**SUBJECT:** Letter of Clarification No. 2

**REFERENCE:** Wortham Building Automation System Upgrade

# GRBCC BAS System Typical Interface Screens

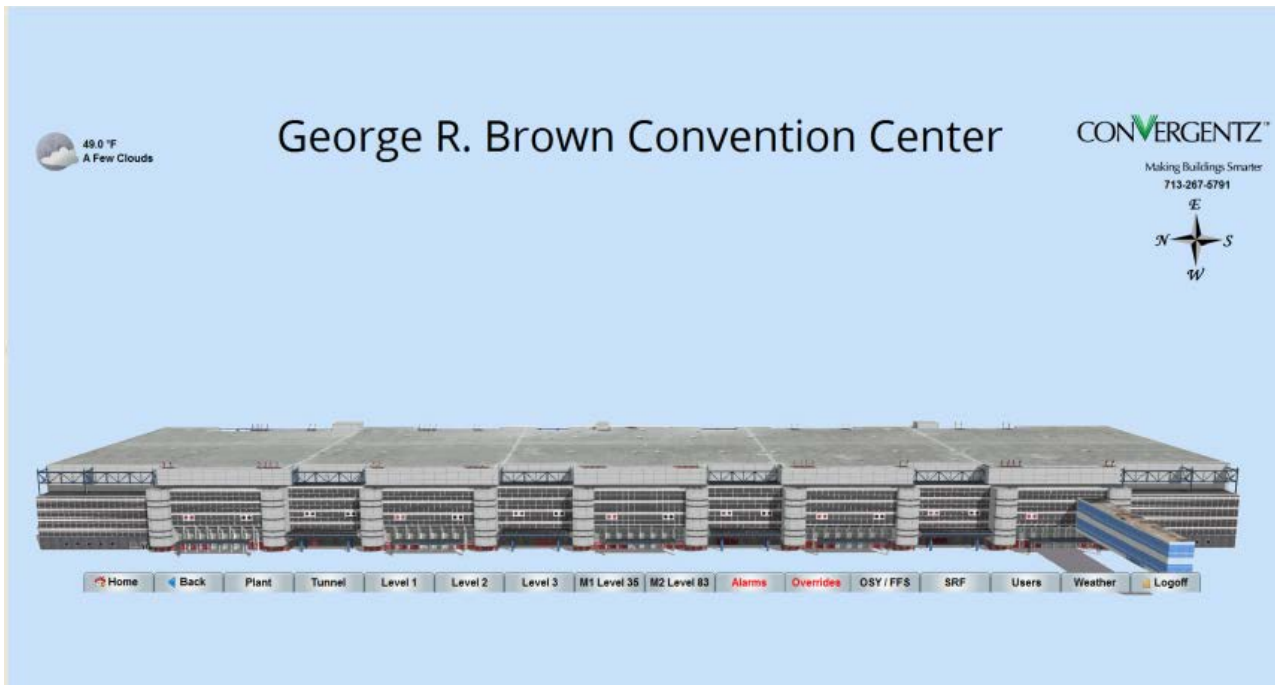
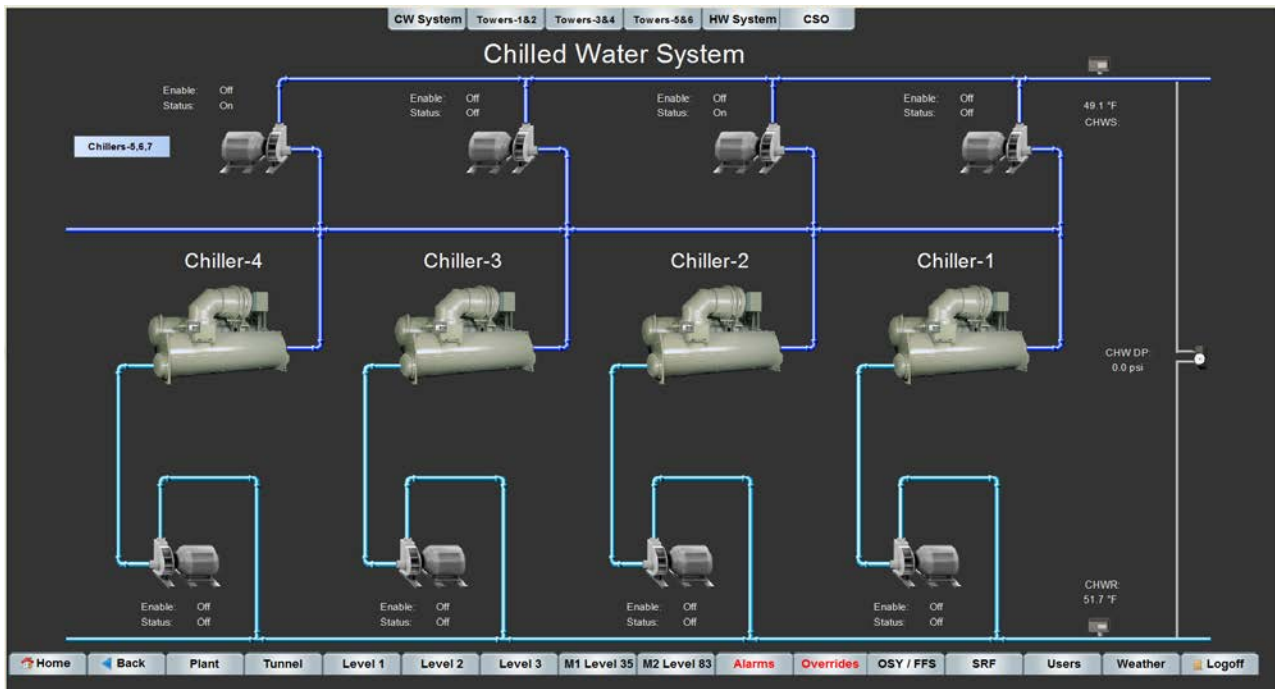
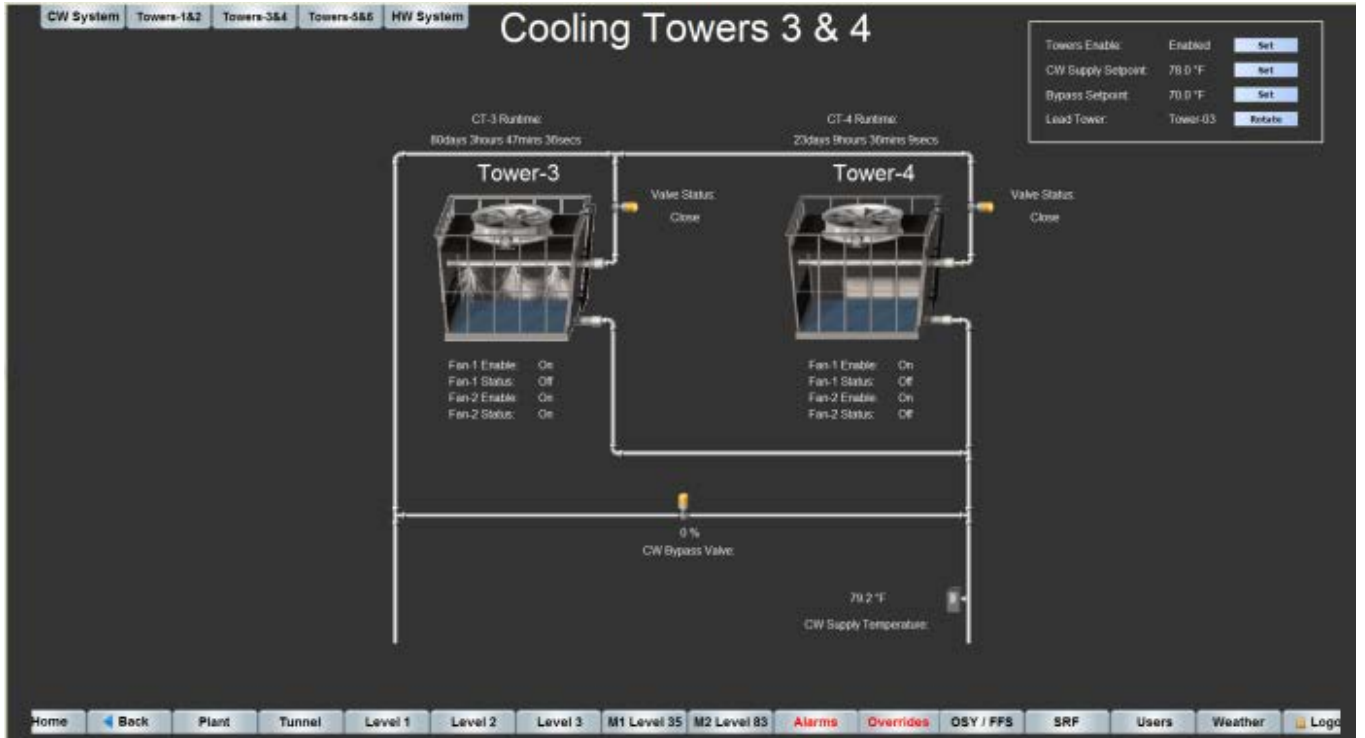
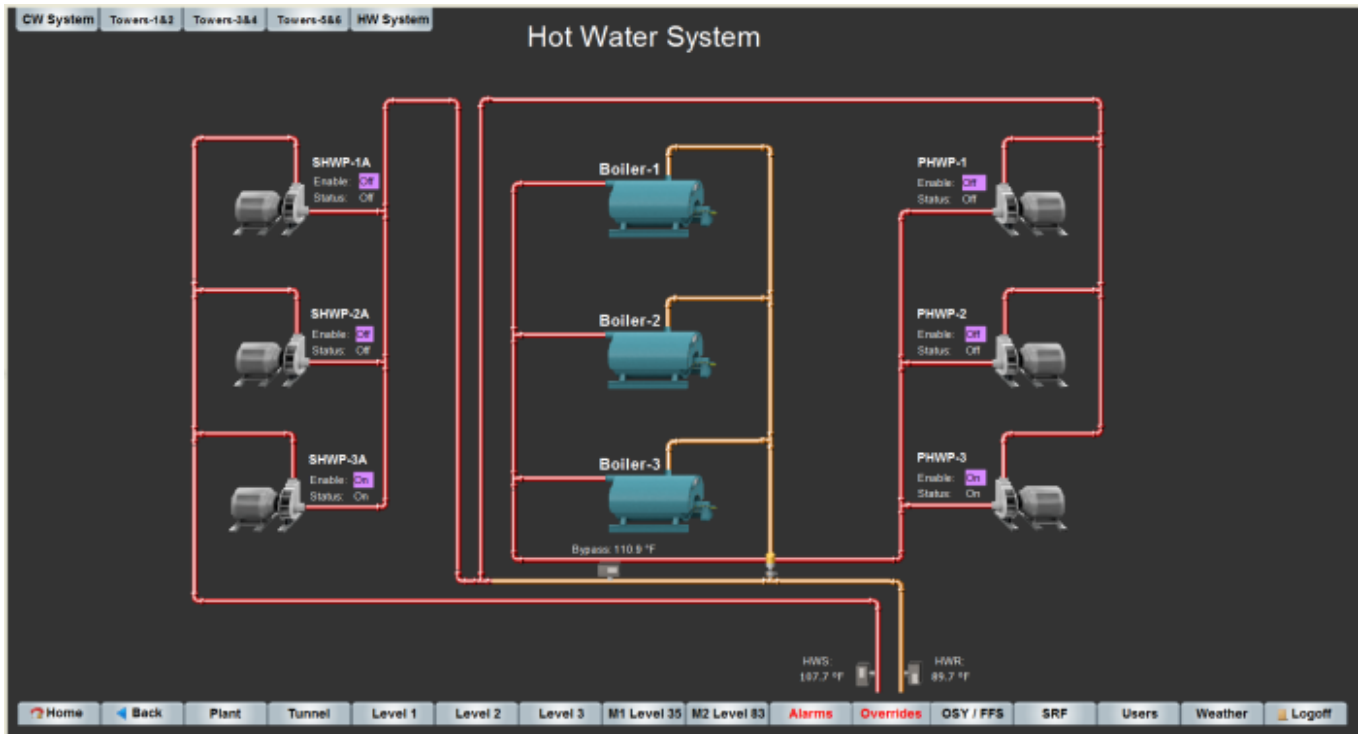
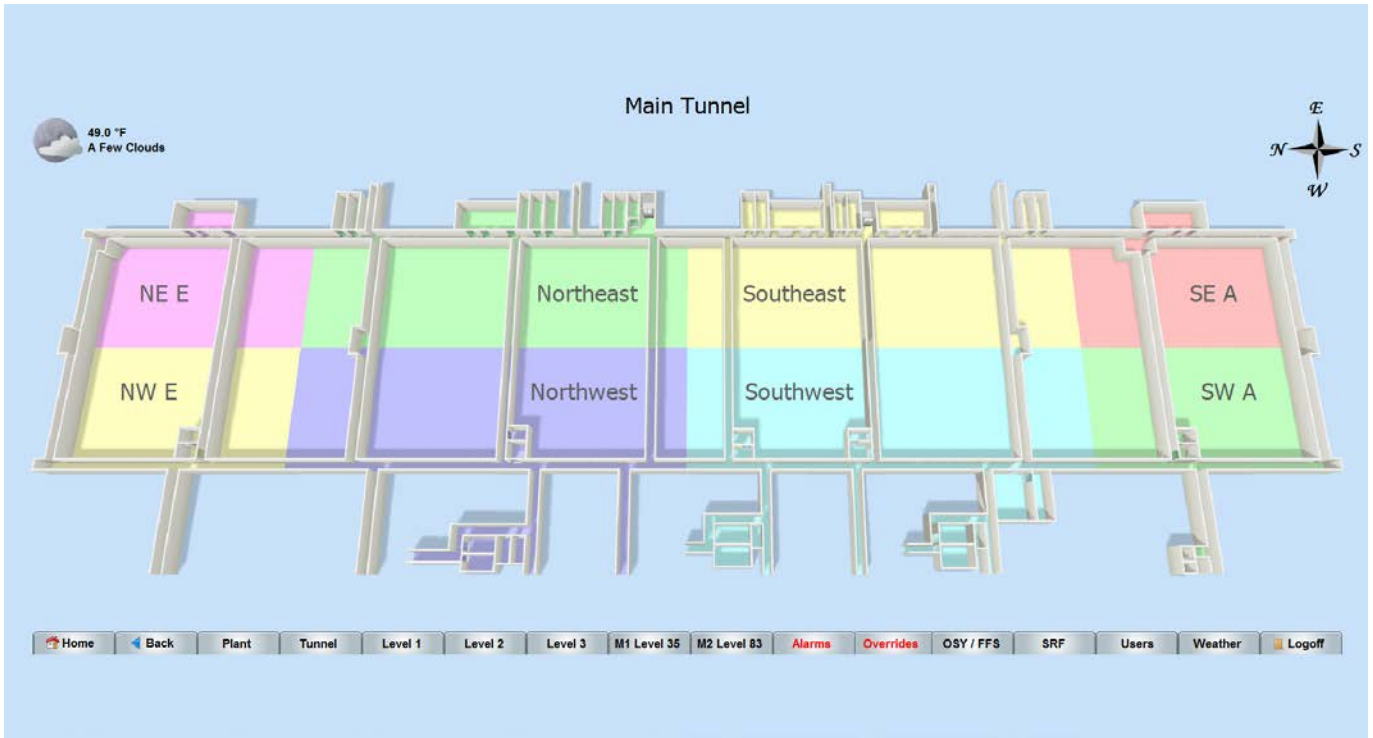
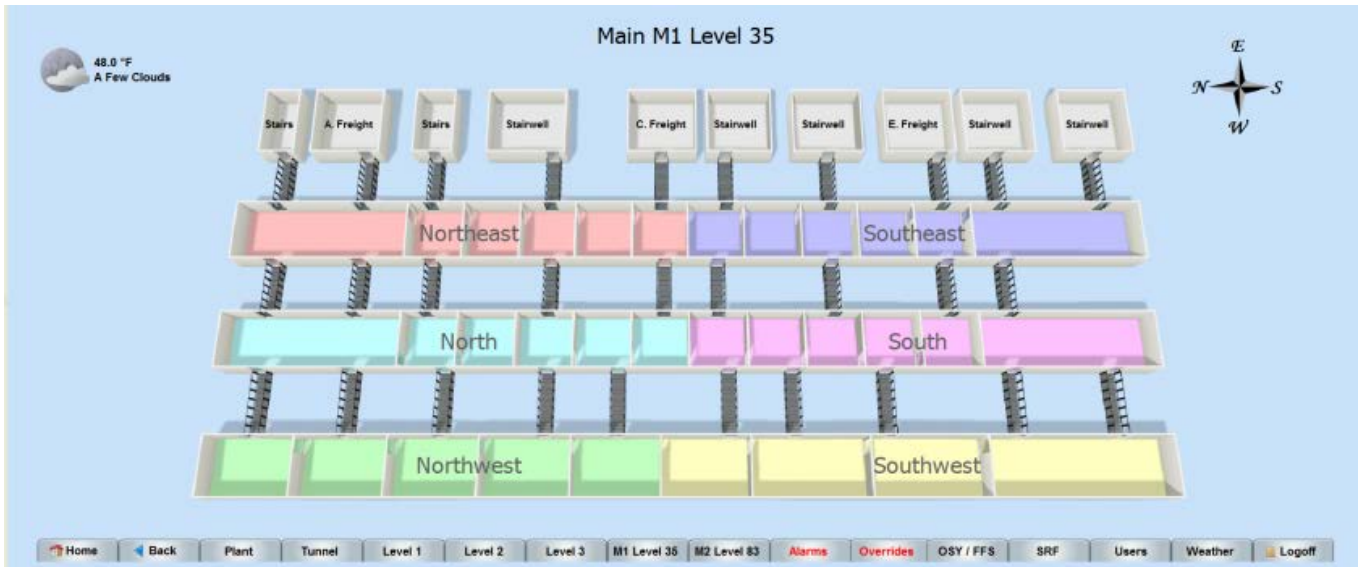
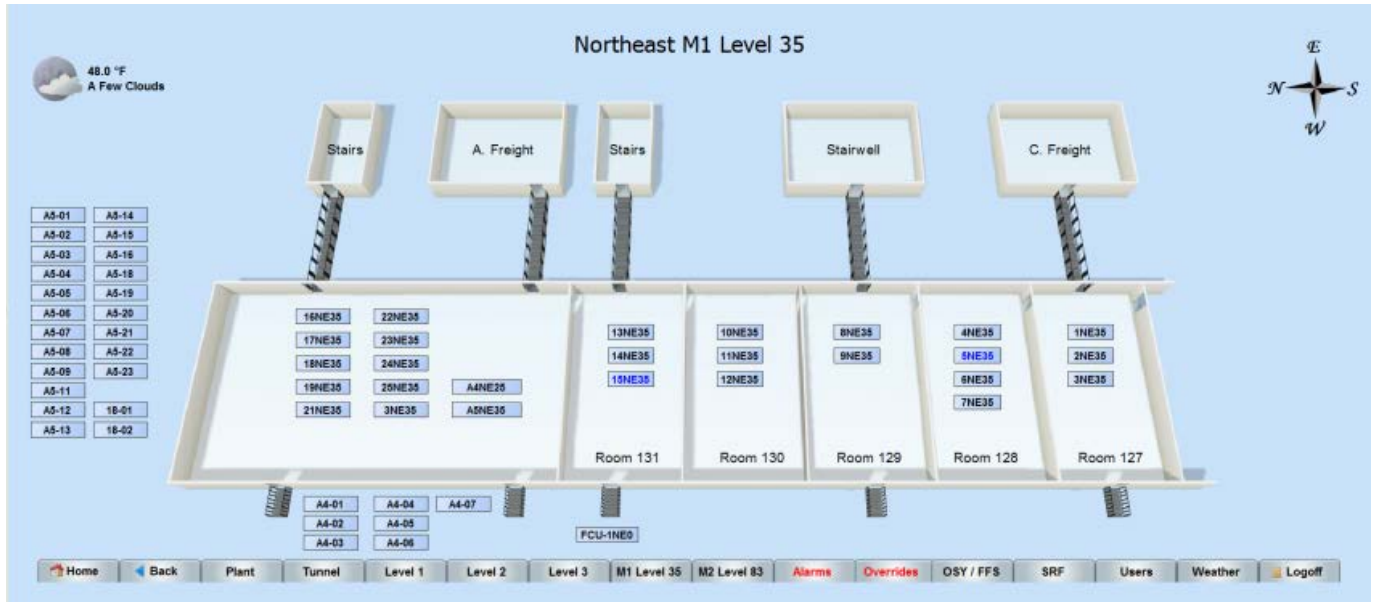
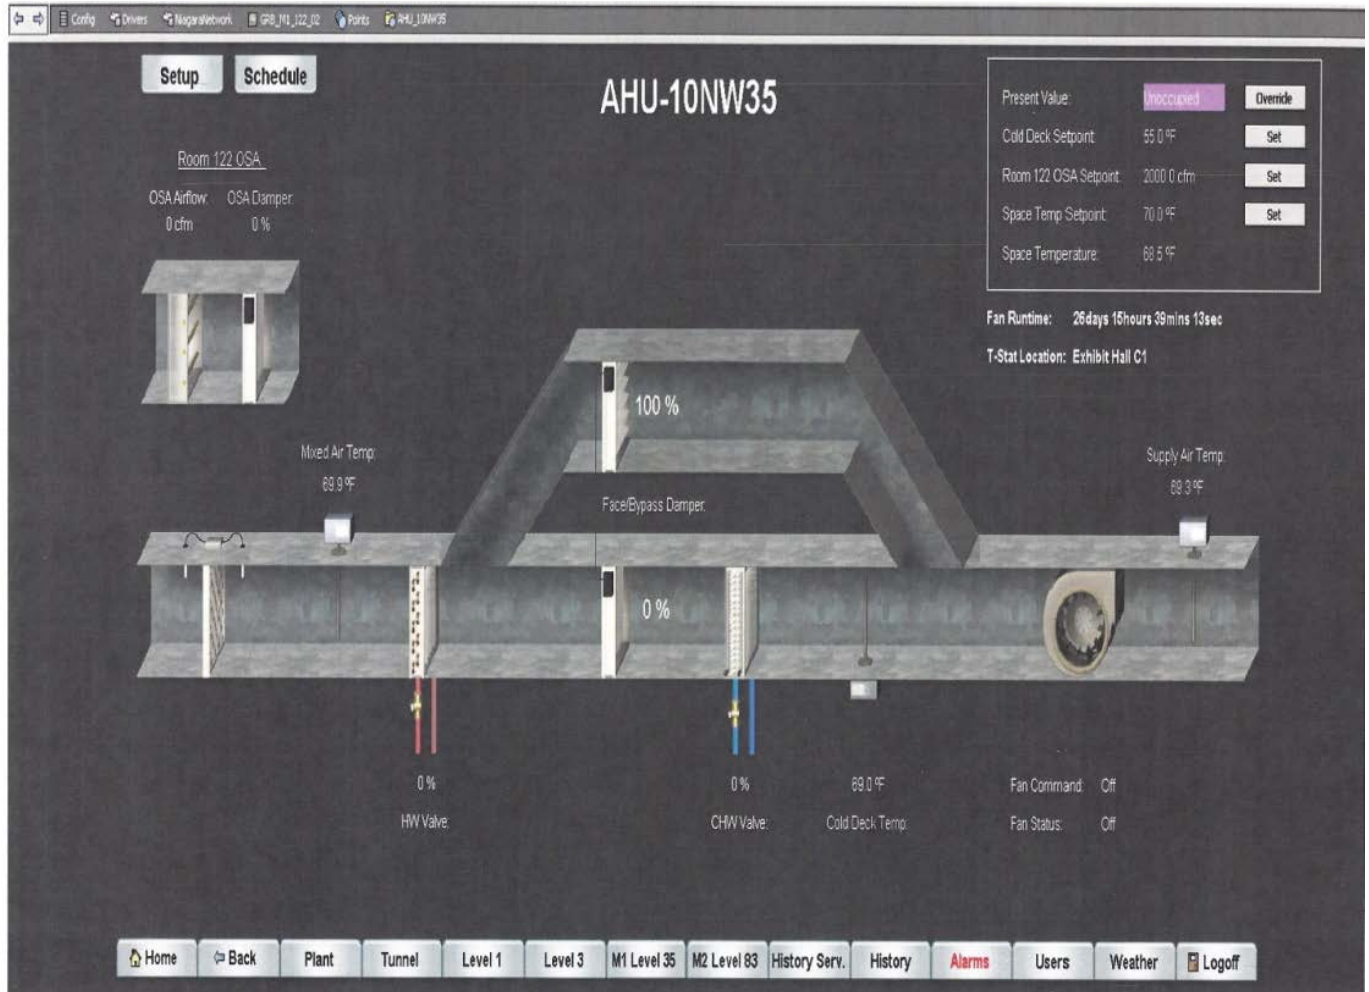
1. **Question:** Can you please provide examples of the graphics for the system located at George R. Brown?

**Answer:** Attached "Typical Screens for Bas System-GRBCC" are sample screen shots from the GRBCC BAS systems ( see requirement in spec section 23 09 23- 1.2-B-7)
